## TECHNICAL MEMORANDUM

**RE: ADDENDUM TO SEATAC DEVELOPMENT SITE RI/FS AND DRAFT CAP**

This Golder Associates Inc. (Golder) Technical Memorandum is an Addendum to the SeaTac Development Site's Remedial Investigation/Feasibility Study (RI/FS) and Draft Cleanup Action Plan (CAP) (Golder 2011a) that were submitted to the Washington Department of Ecology (Ecology) on April 14, 2011 and underwent a public comment period during May 2011. This addendum will be attached to Ecology's Responsiveness Summary to the Final CAP. The Port of Seattle comments (presented in a letter dated May 27, 2011) represented the bulk of comments received by Ecology. A conference call with Ecology, the Port of Seattle and the SeaTac Development Site's PLP Group (PLP Group) representatives was held on June 14, 2011 and a follow-up meeting was conducted on June 27, 2011 to discuss the Port of Seattle's comments. Based on the conference call and meeting with Ecology and the Port of Seattle, each comment was discussed and categorized according to the four following criteria:

FIGURE 1  
**TILL LAYER OBSERVED IN BOREHOLES**  
SEATAC DEVELOPMENT SITE/RI/FS/WA

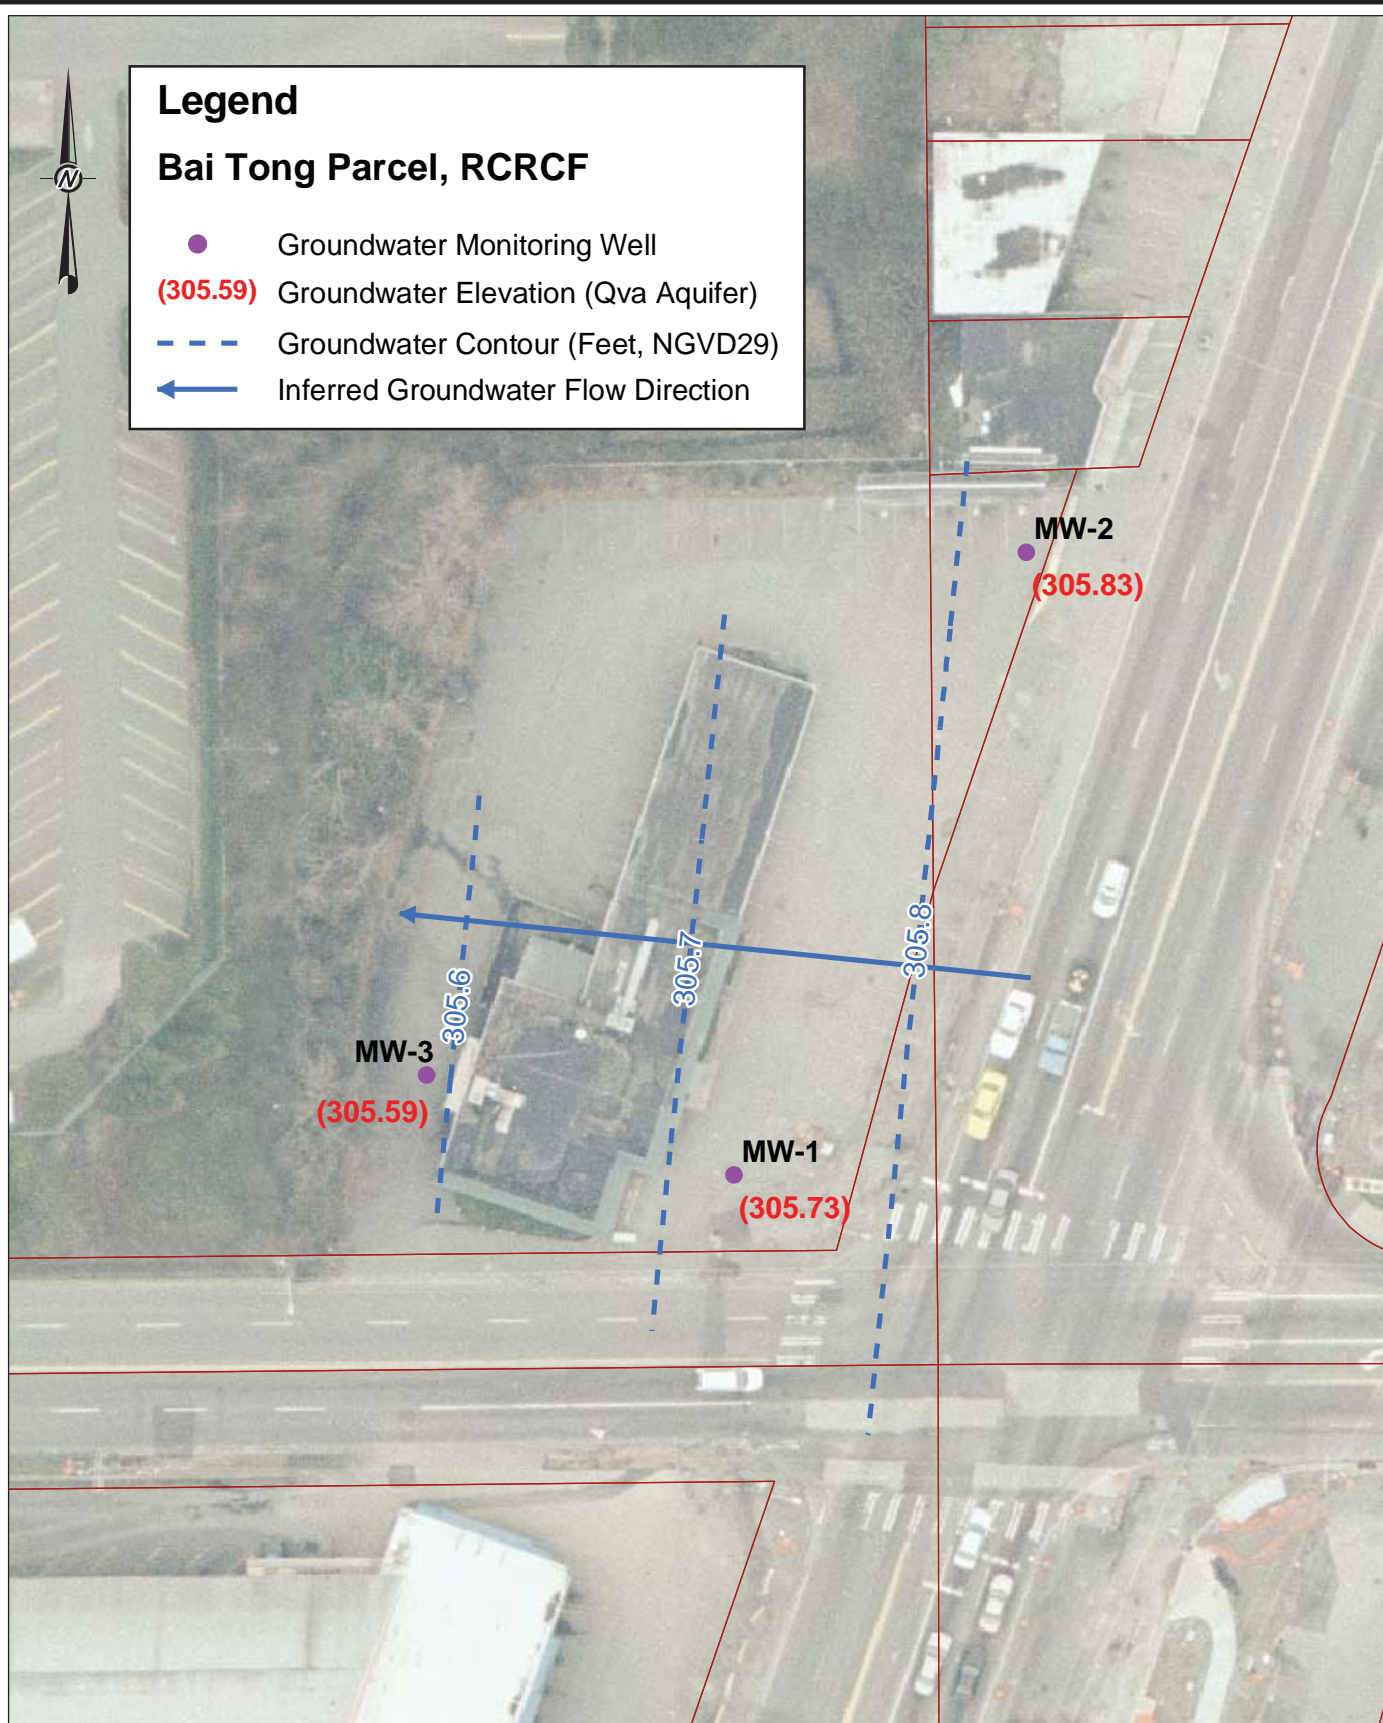
3. Preparation of geologic cross sections is highly recommended for hydrogeologic evaluation and for review of conclusions and proposed remediation alternatives. No geologic cross sections were presented in the RIFS or DCAP.

4. The presence or absence of glacial till could affect contaminant migration and soil vapor pathways. Preliminary review indicates that the till unit appears to be discontinuous within the identified boundaries of the contaminant plumes<sup>1</sup>. A map of till thickness, and identification of any other confining units, would be very helpful for interpretations and evaluations.

**RESPONSE:** Geologic cross-sections are typically provided in RI/FS documents to illustrate complex geologic stratification. The geologic stratification at the site is not complex and therefore does not require detailed geologic cross-sections for illustration, but attached Figure 1 identifies the extent of the till discovered during site investigations.

**RESPONSE:** The till at the site is present in the eastern, central and southern portions of the facility. However, the till is absent in the northwestern portion of the facility and was not observed in off-site borings within South 160<sup>th</sup> Street or in borings on the cemetery property to the west of the site where groundwater impacts are present. Figure 1 shows the limits where till was observed during borehole drilling. There were no other confining units of any extent or continuity observed during borehole drilling at the site.

FIGURE 2  
**GROUNDWATER FLOW DIRECTION  
ON THE PORT OF SEATTLE  
PROPERTY IN 2004**  
RW/MASTERPARK LOT C RI/FS & REMED/WA

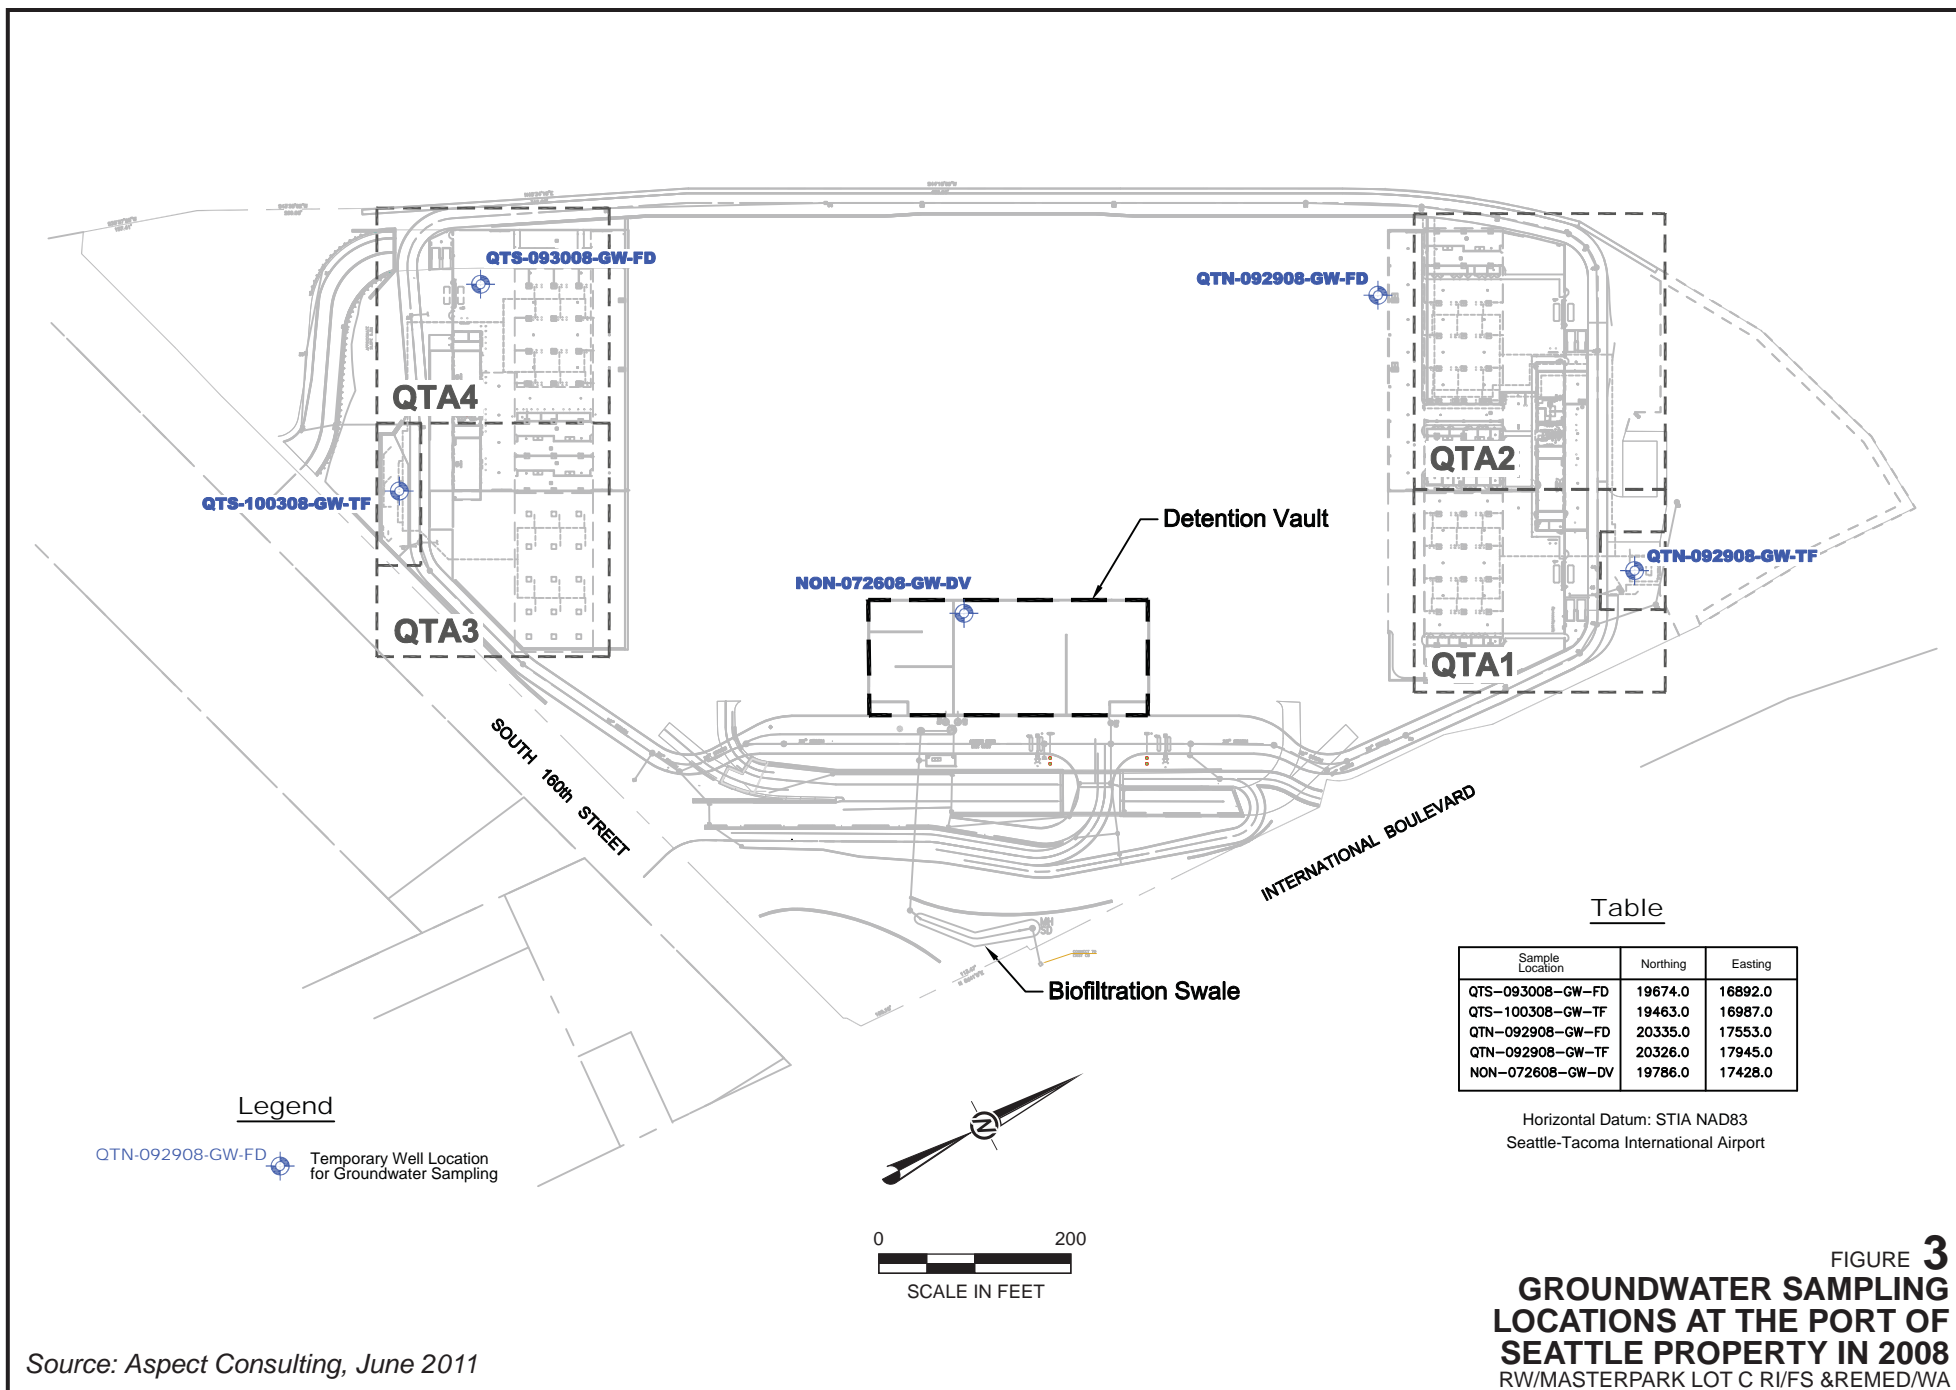
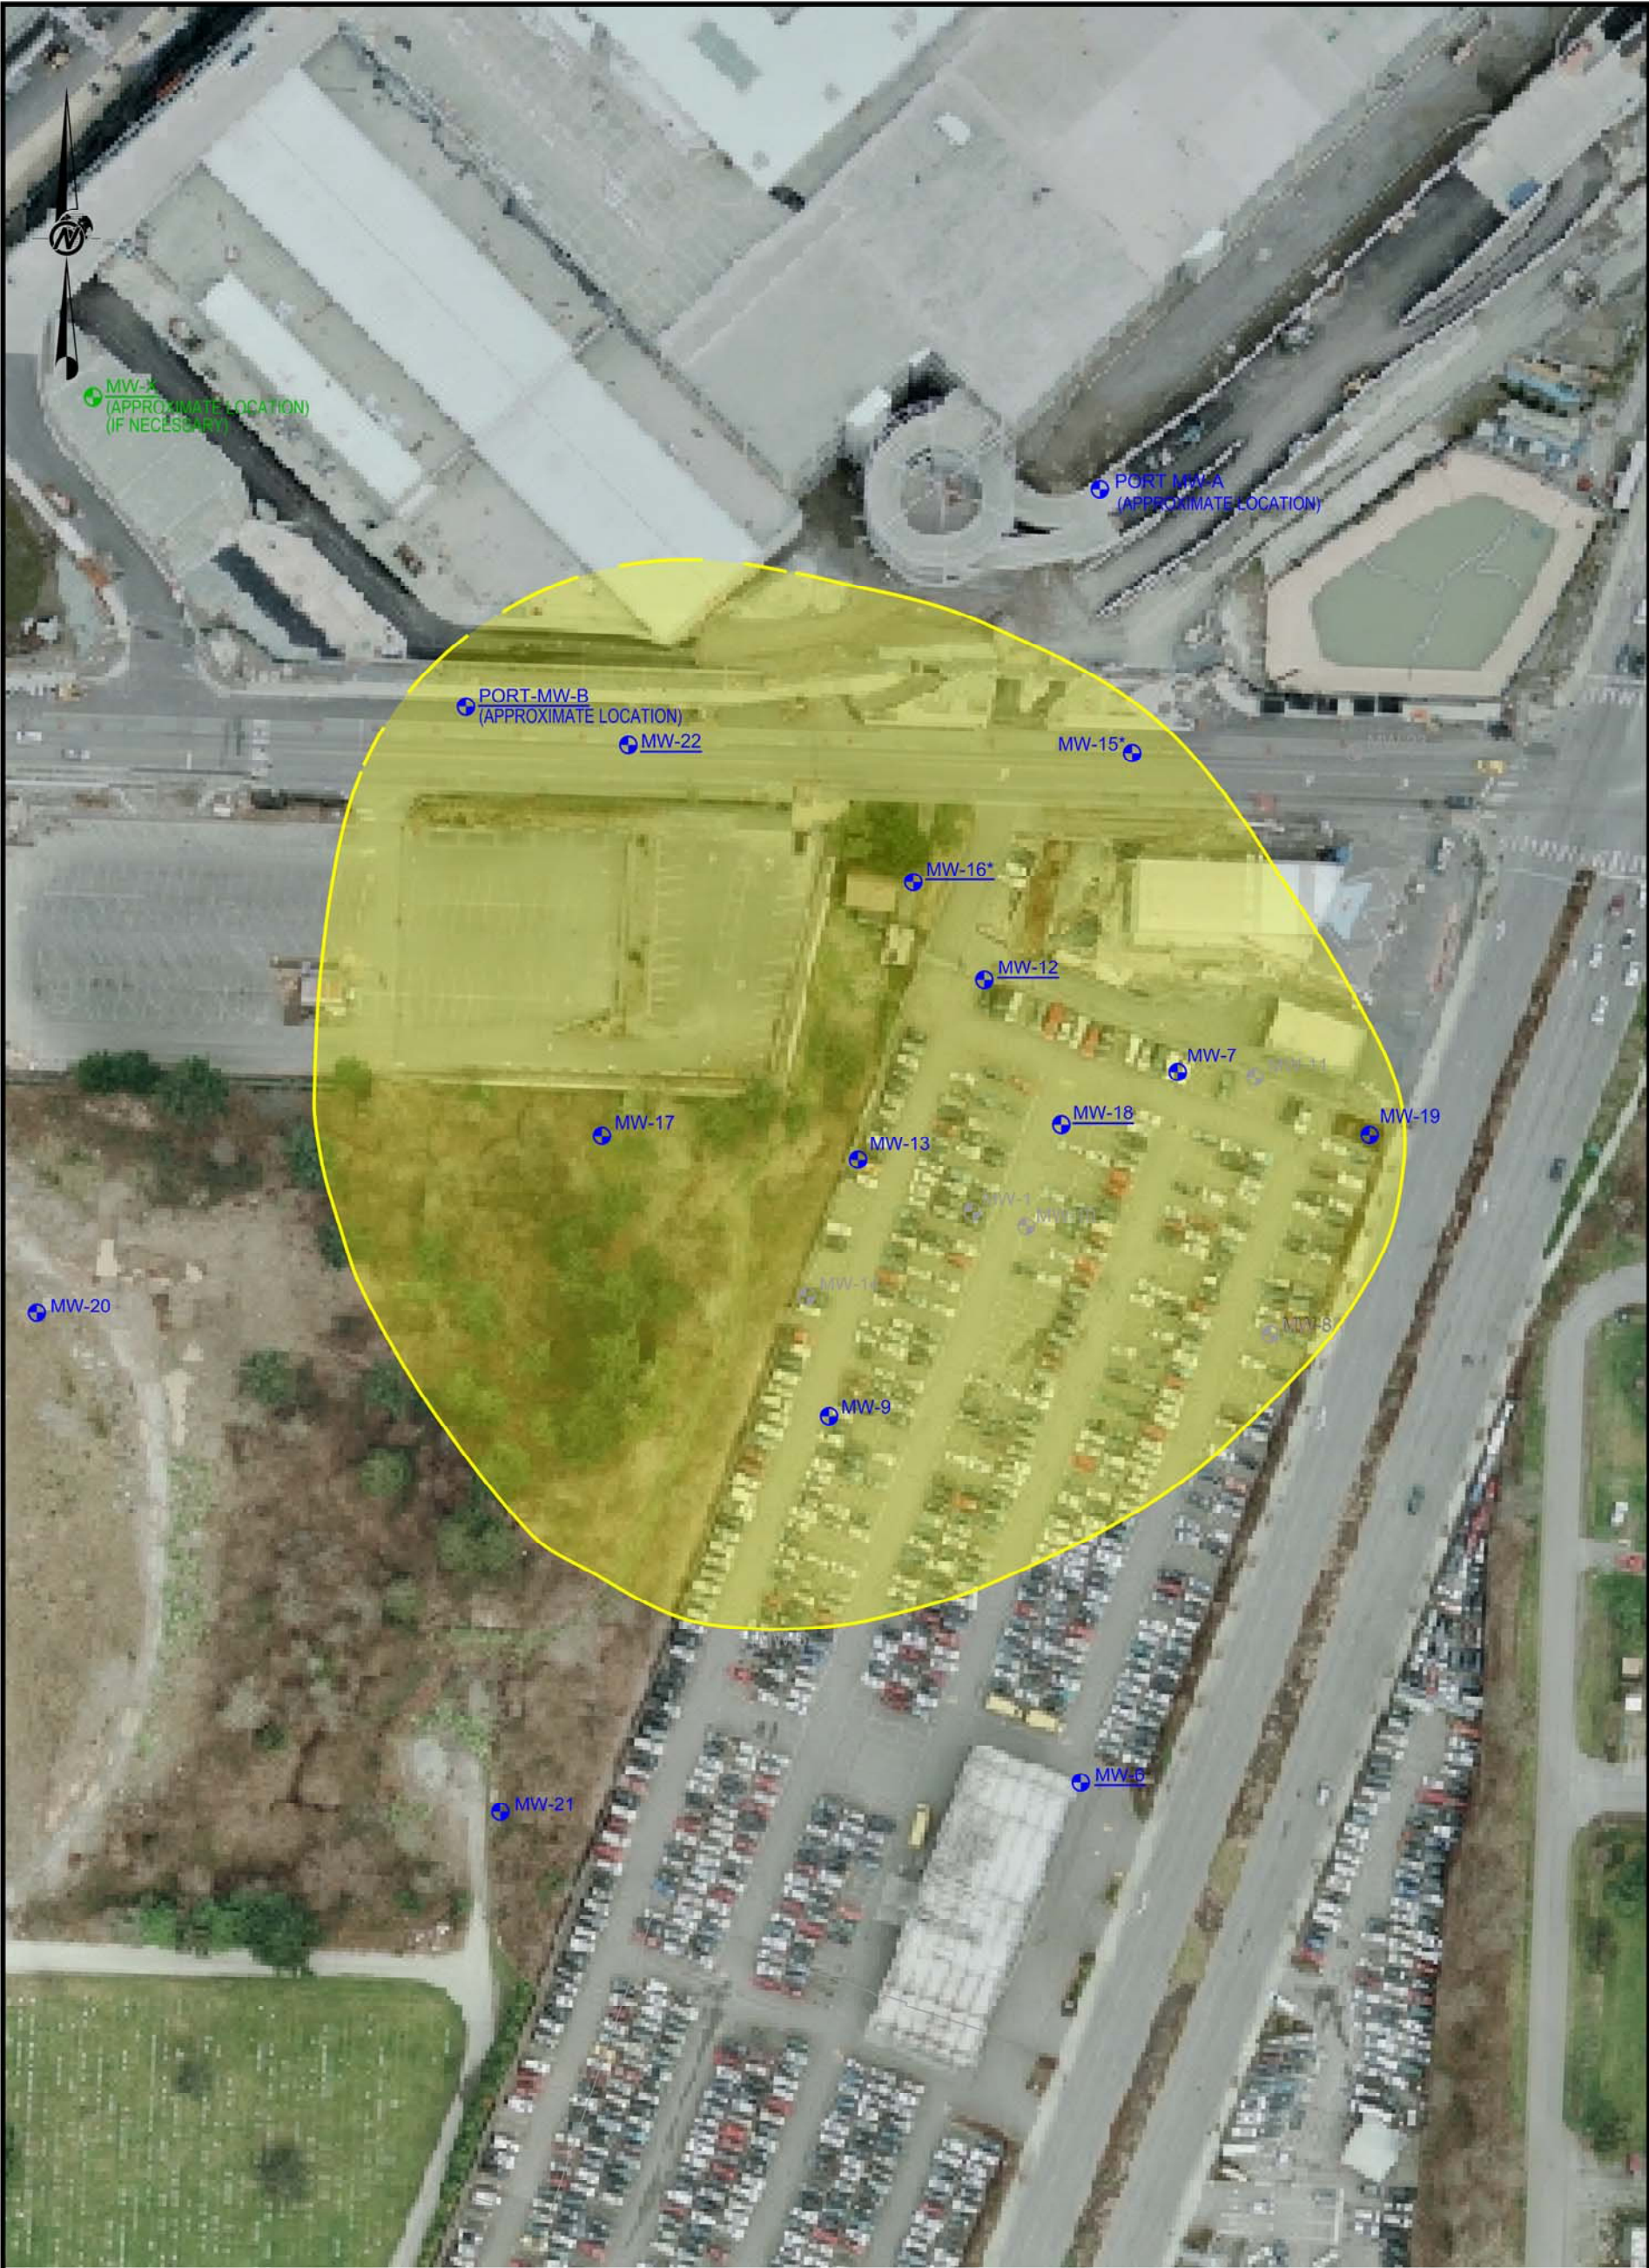
5. About thirteen wells were used to define groundwater flow directions south of South 160<sup>th</sup> Street. However, there are no monitoring wells north of South 160<sup>th</sup> Street to define local flow directions on the Port property. Since the groundwater contours in this area are relatively flat (i.e. hydraulic gradients are small), there is no guarantee that flow directions on the Port property are the same as on the MasterPark site. Item 6, below, notes that there are logistical constraints in locating wells on the Port property.

**RESPONSE:** A previous groundwater investigation by the Port of Seattle in 2004 was conducted north of South 160<sup>th</sup> Street near the intersection of South 160<sup>th</sup> Street and International Boulevard (EMS 2004). The Port of Seattle installed monitoring wells Port MW-1, Port MW-2, and Port MW-3 shown on the attached Figure 2 (as also depicted on Figure 4 of the Draft CAP). The Port of Seattle

concluded that groundwater within the Qva Aquifer was flowing toward the west, based on groundwater levels measured in their monitoring wells. Golder monitored water levels in these Port of Seattle wells and also concluded that the groundwater was flowing westerly on Port property north of South 160<sup>th</sup> Street. The analytical results of groundwater from the Port of Seattle wells did not detect any petroleum hydrocarbons or associated gasoline compounds in 2004 (EMS 2004).
